PROJECT: Sky View Pines - update #7

CITY OF LAS VEGAS INTER-OFFICE MEMORANDUM			DATE: August 29, 2012	
TO: Land Development Services Department of Public Works			FROM: Albert Sung, P.E. Flood Control Project Engineer Department of Public Works	
SUBJECT:		Drainage Study for:		COPIES TO: L. R. Nelson Consulting Engineers Nevada H.A.N.D. Bart Anderson, P.E., DevCo CNLV
Sky View Pines – Update #7				
Cross Streets:	SWQ of Owens Avenue & Main Street			
File Number:	F:\Depot\DSMemos\DS4315K.doc			
Parcel Number:	139-27-502-003			
Zoning Action:	SDR-28121			
FEMA Flood Zone	YES	NO	X	
Proposed Storm Drain	YES	NO	X

**UPDATE #7 TO THE
TECHNICAL DRAINAGE
STUDY FOR
SKY VIEW PINES**

**Re: Update #7 to the Technical Drainage Study for Sky View Pines
(DS4315)**

GRADING PLAN 2

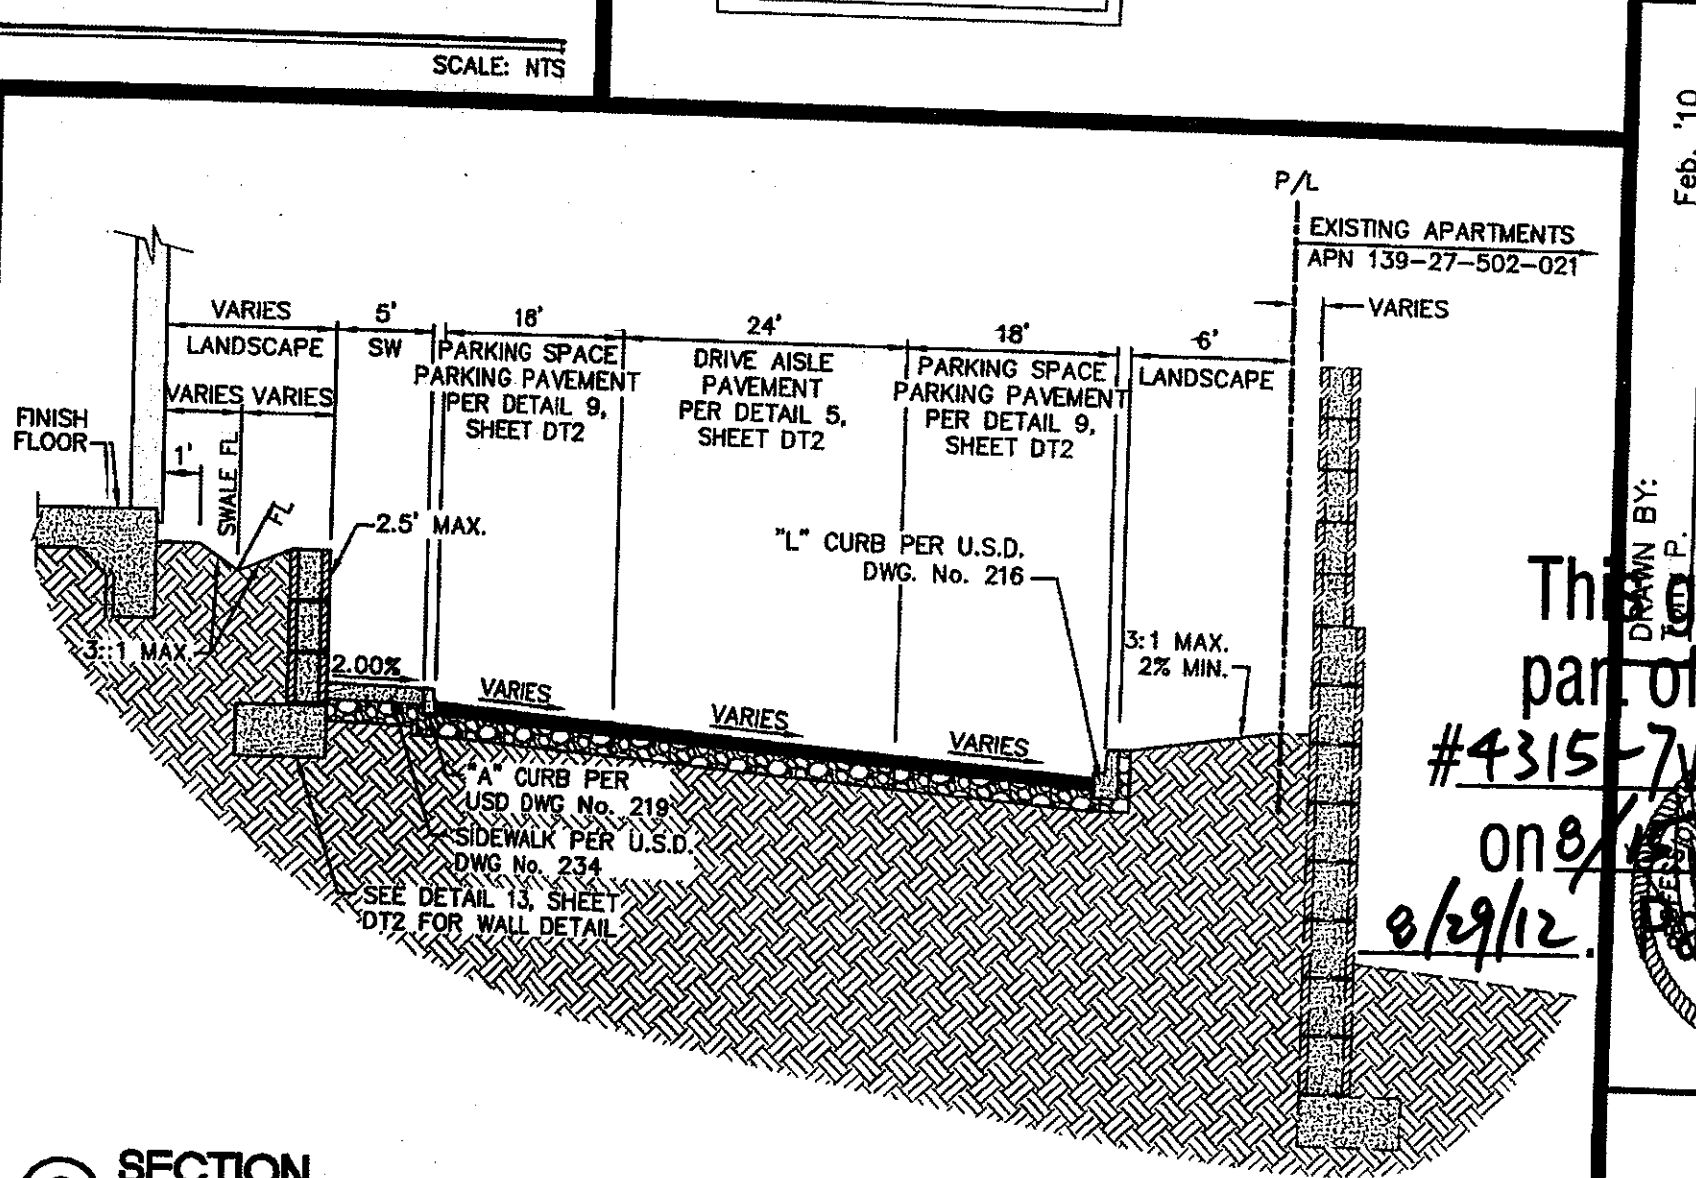
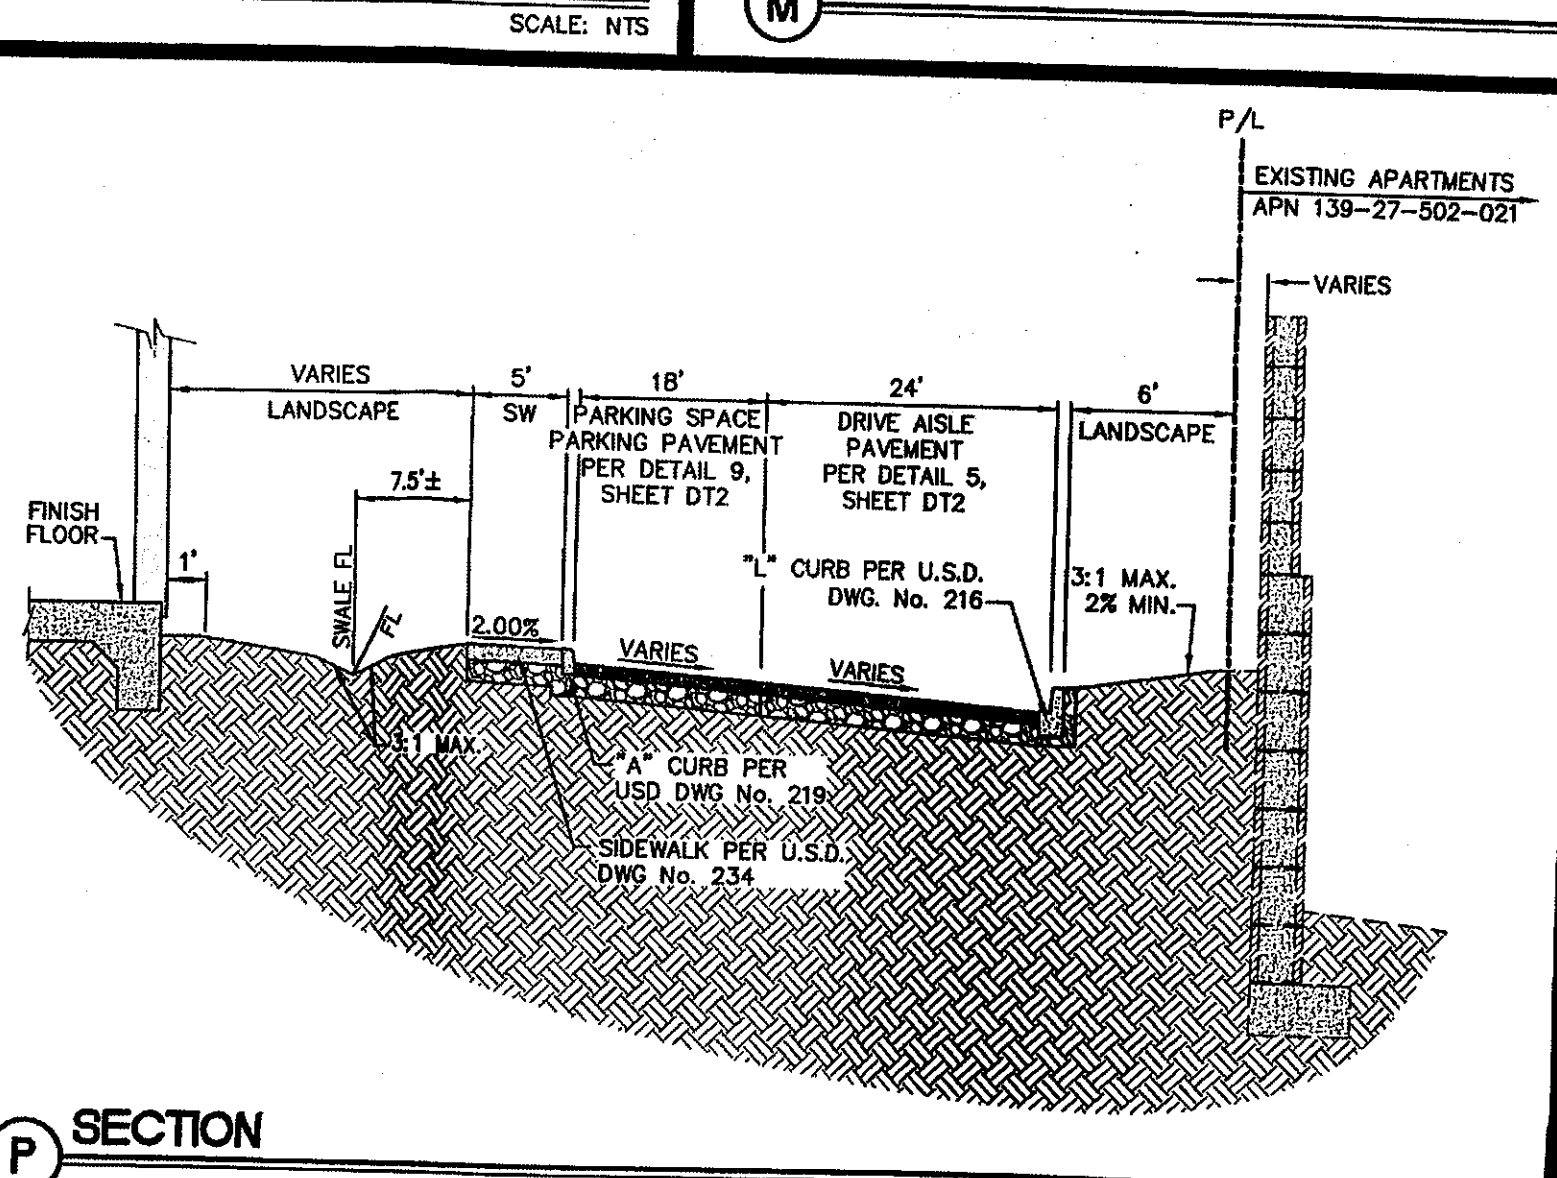
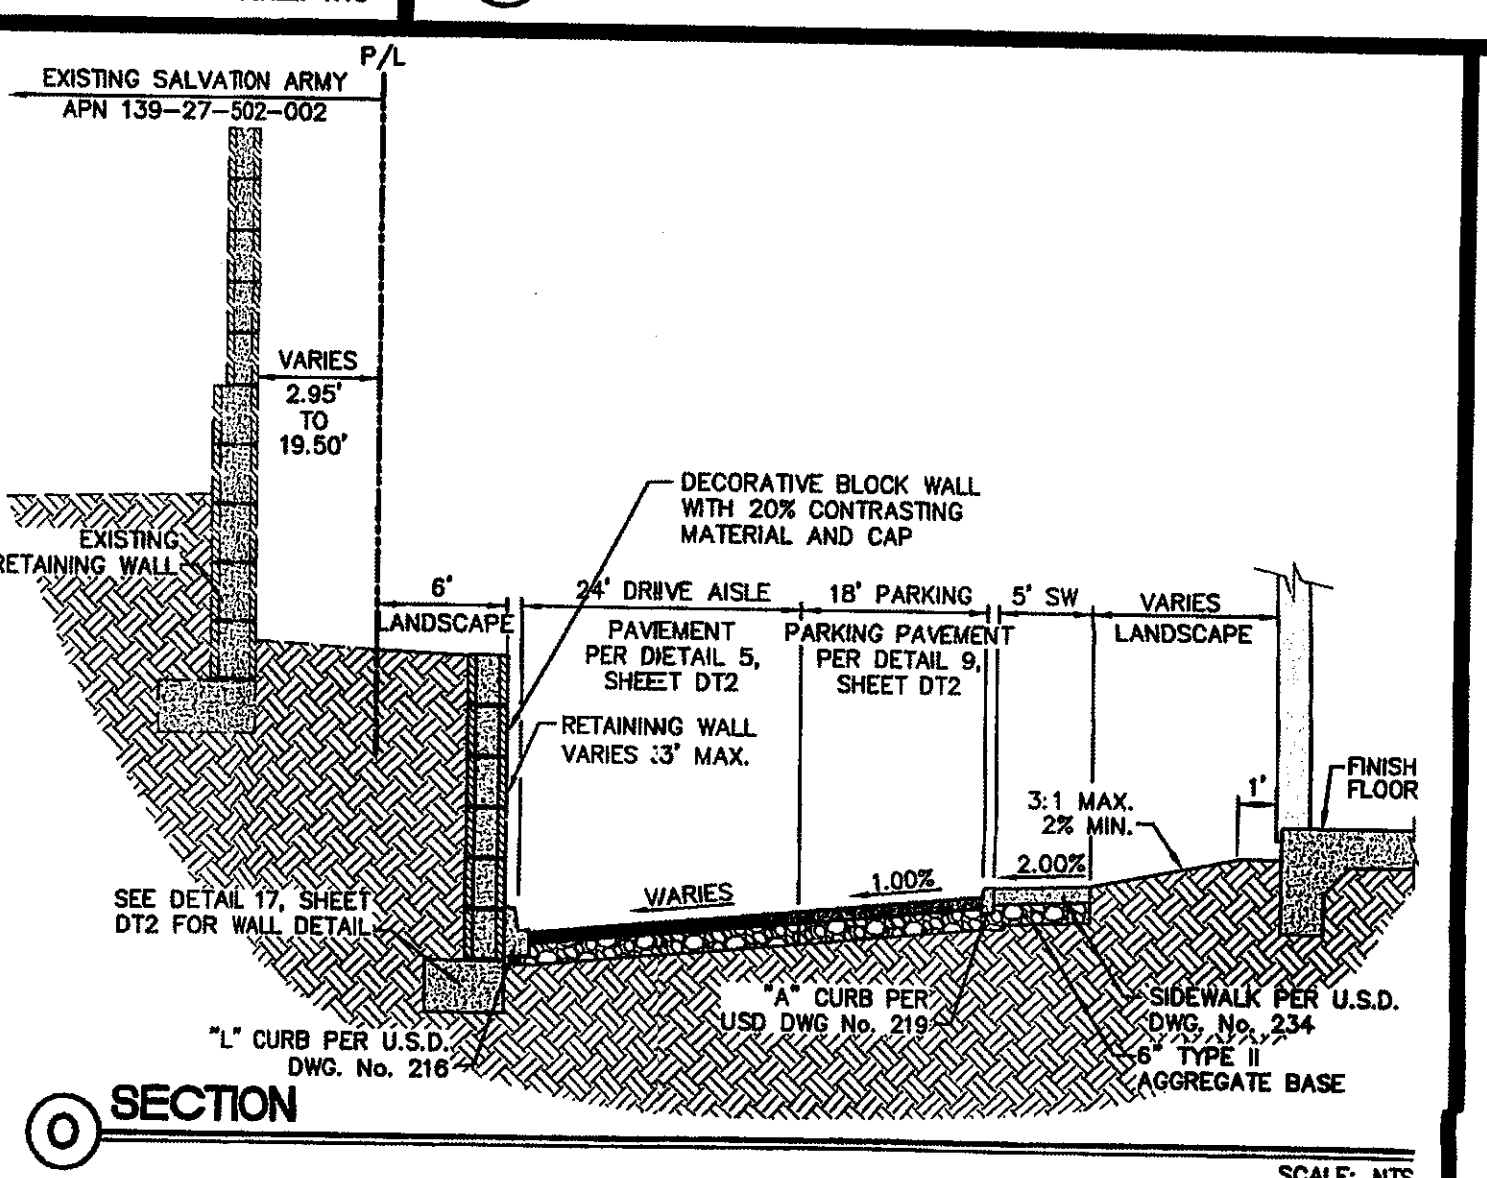
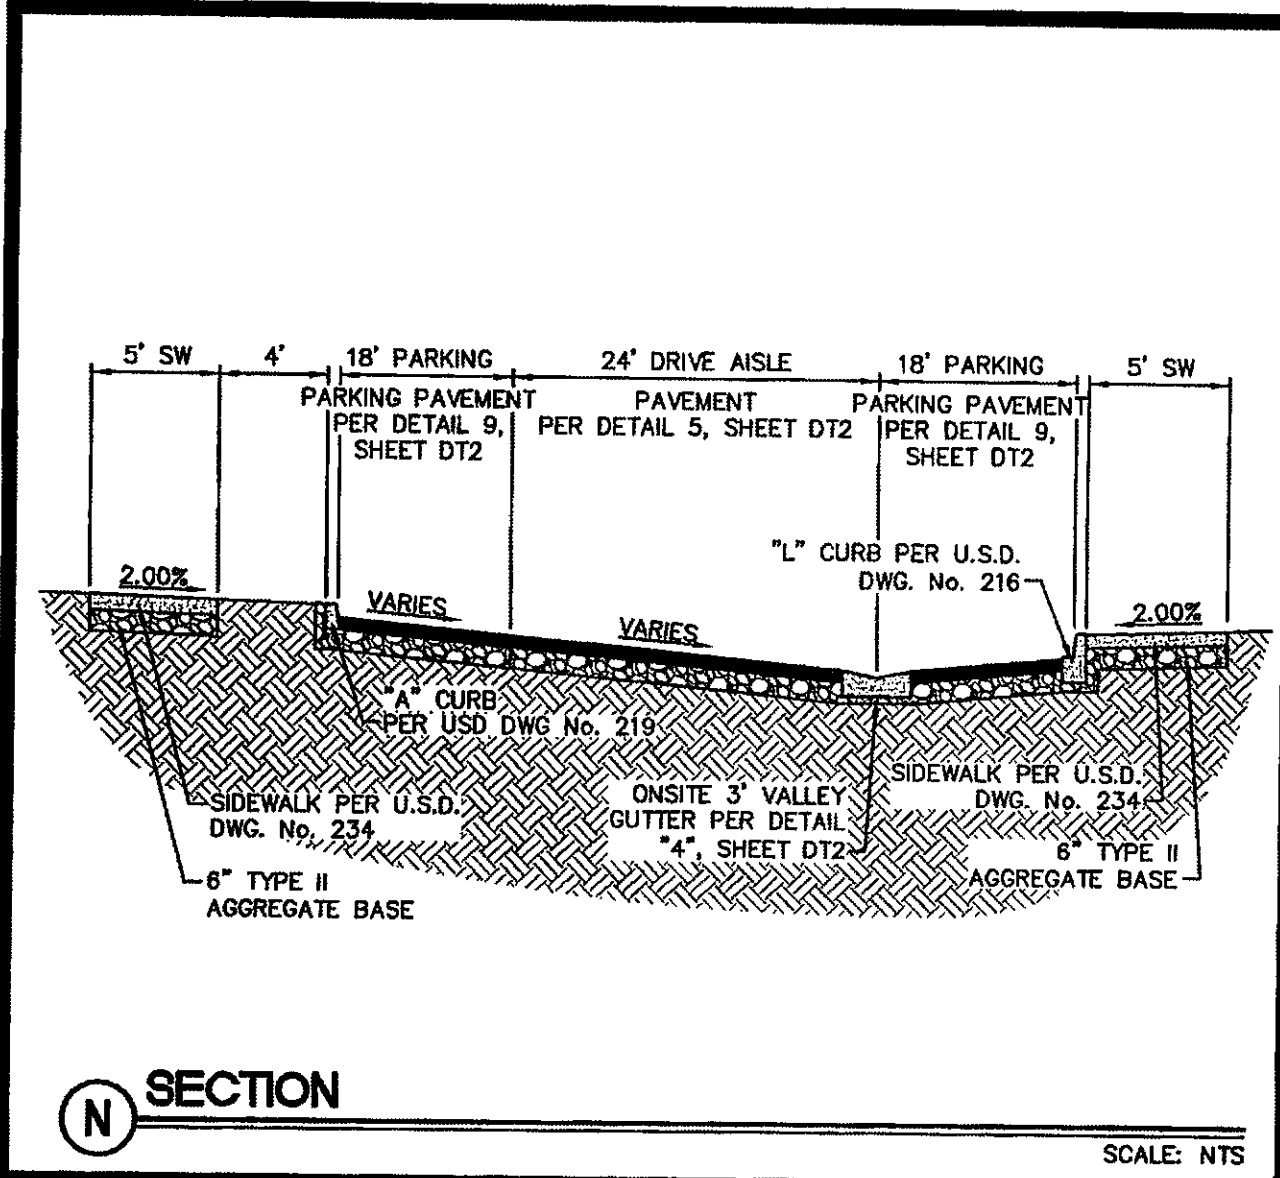
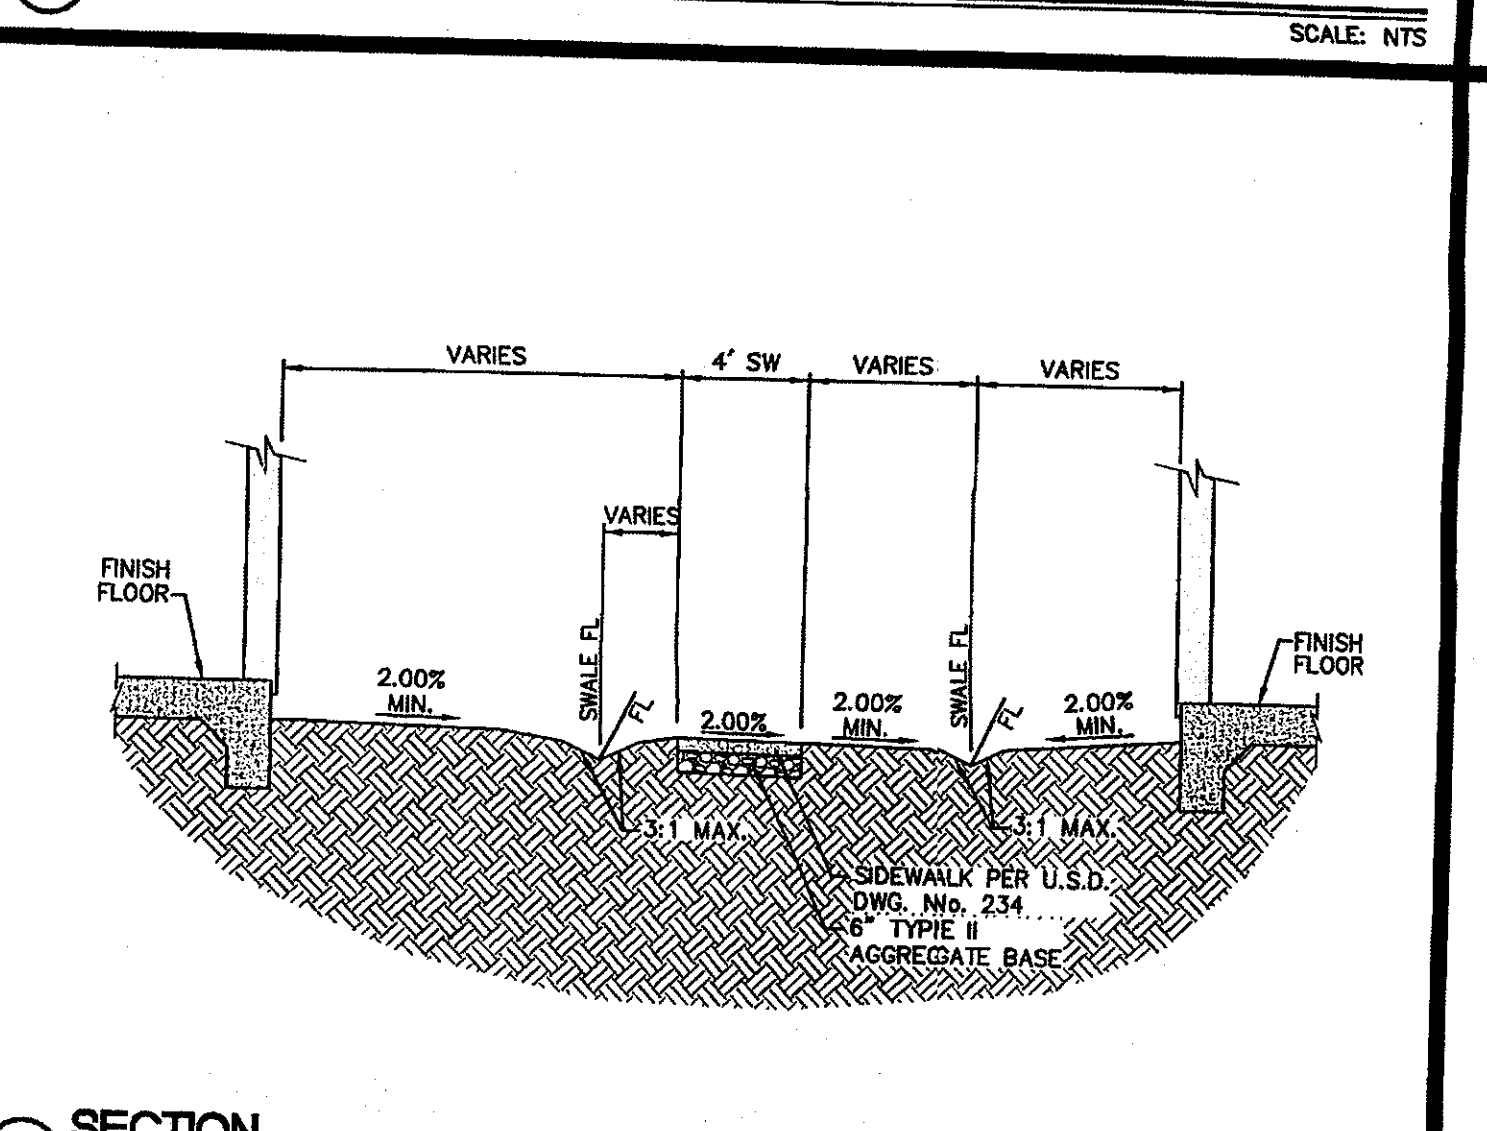
1. **Sheet GR2:** Revise a typo error of finished grade elevation at the southwest corner of the proposed "Activity Building" from 29.25 FG to "**39.25 FG**".
